SIB 63 06 13

RECALL CAMPAIGN 13V-407: REPLACE REAR BULB CARRIERS (SIDE PANEL)

This Service Information Bulletin (Revision 1) replaces SI B63 06 13 **dated November 2013**.

New part with ground cable

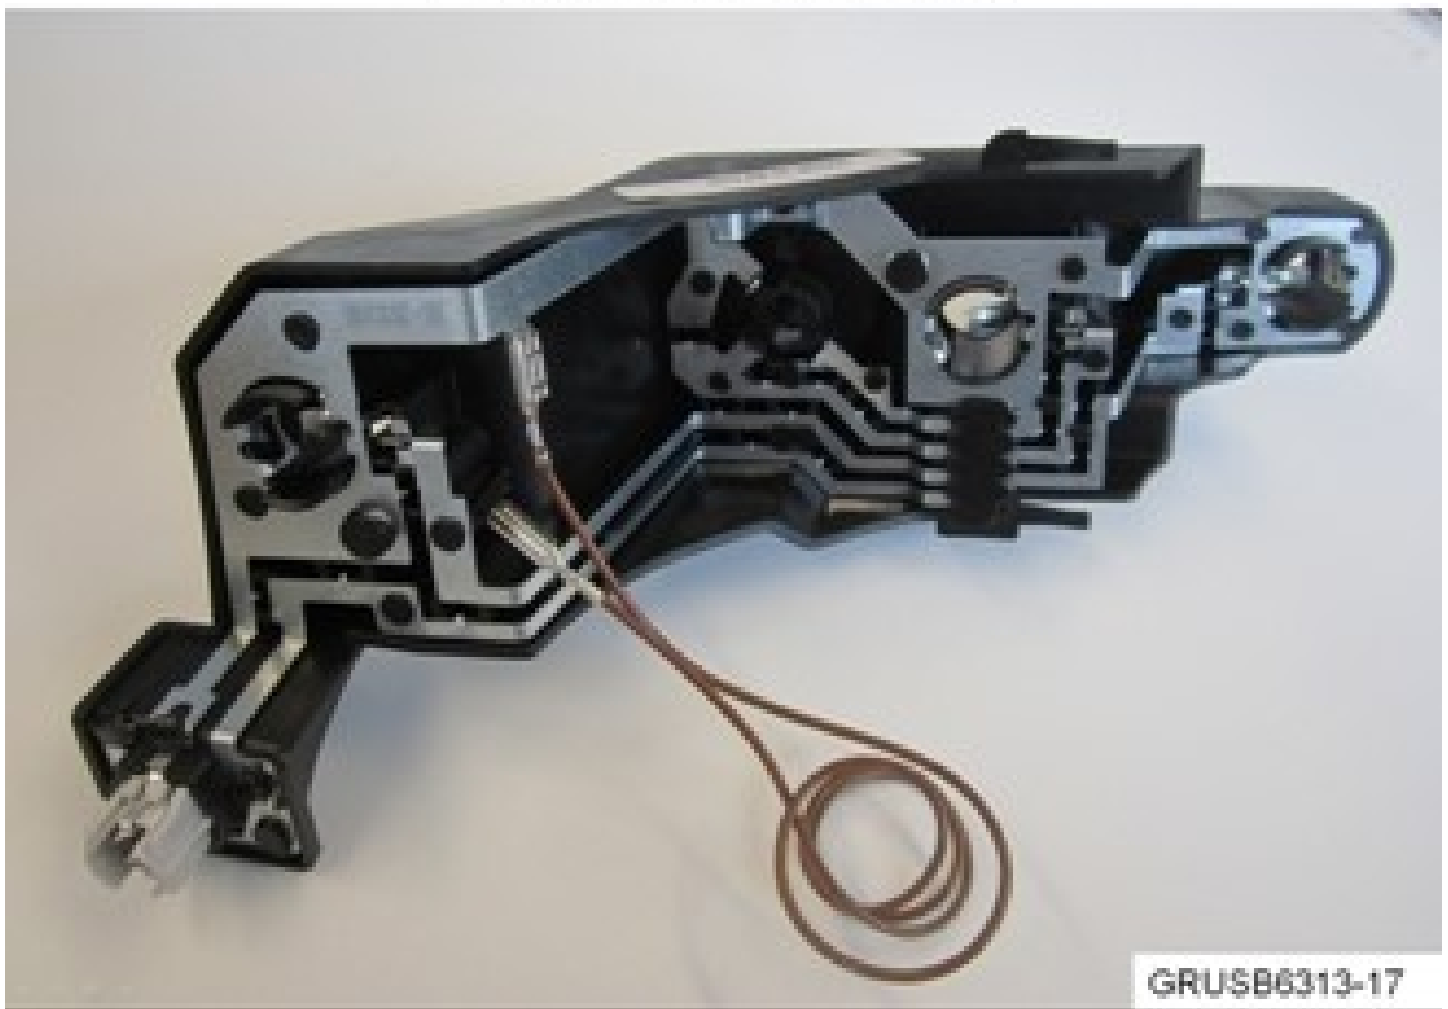
The pictures below show the new part with the additional ground cable and final wire routing.

3. Using the E60 service repair kit, **replace both carriers**.
4. Inspect both connector socket housings and if necessary, replace **only** the affected side where corrosion or thermal damage is present. Refer to ISTA Repair Instruction 63 21 055, "Replace a socket housing for left or right-hand boot lid light."
